Detailed Site Plan Fairway Estates at Glenn Dale

DSP-19007

STAFF REPORT

SUBJECT: Detailed Site Plan DSP-19007
Type 2 Tree Conservation Plan TCP2-010-2020
Fairway Estates at Glenn Dale

HISTORIC VIEWSHEDS

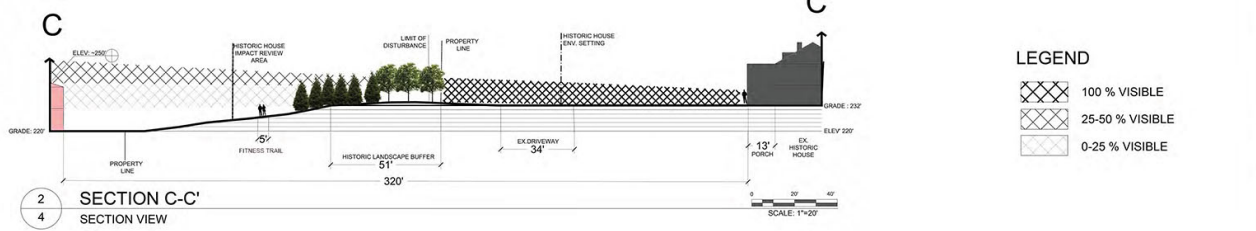
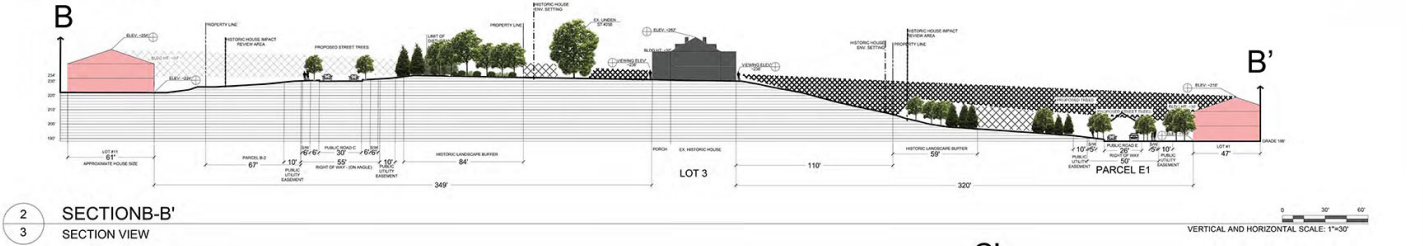
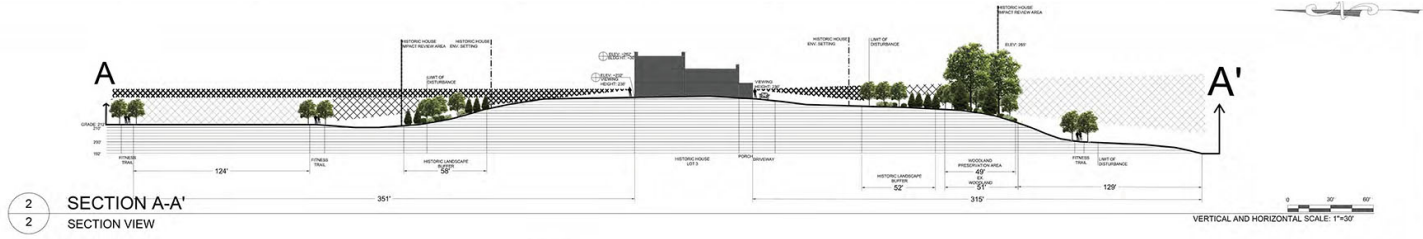
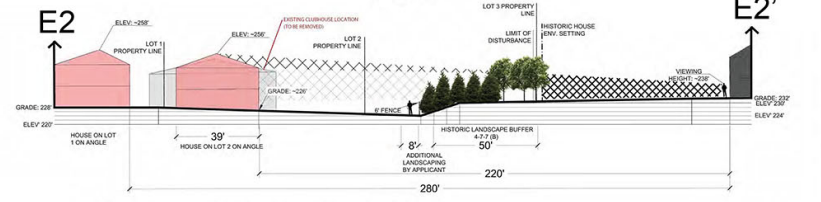
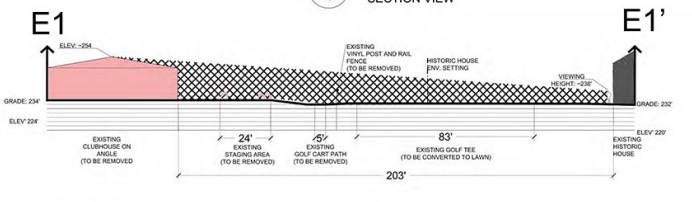
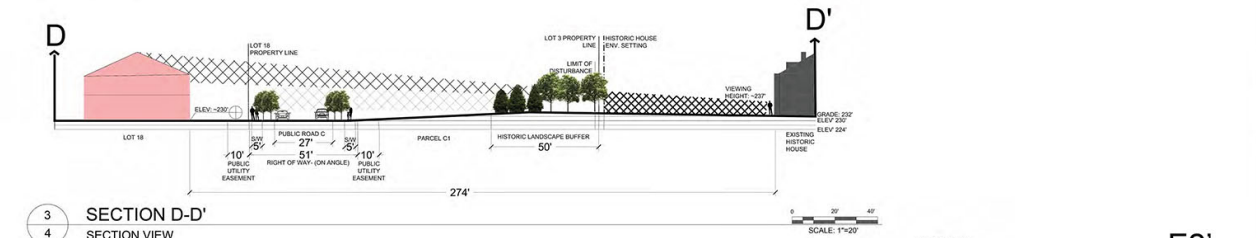
The applicant provided a viewshed study from the Prospect Hill Historic Site to the closest lots, Lots 1 and 2. The applicant's exhibit shows that the proposed landscape buffer that is required around the Prospect Hill Historic Site will provide sufficient screening for the houses that will be sited on Lots 1 and 2.
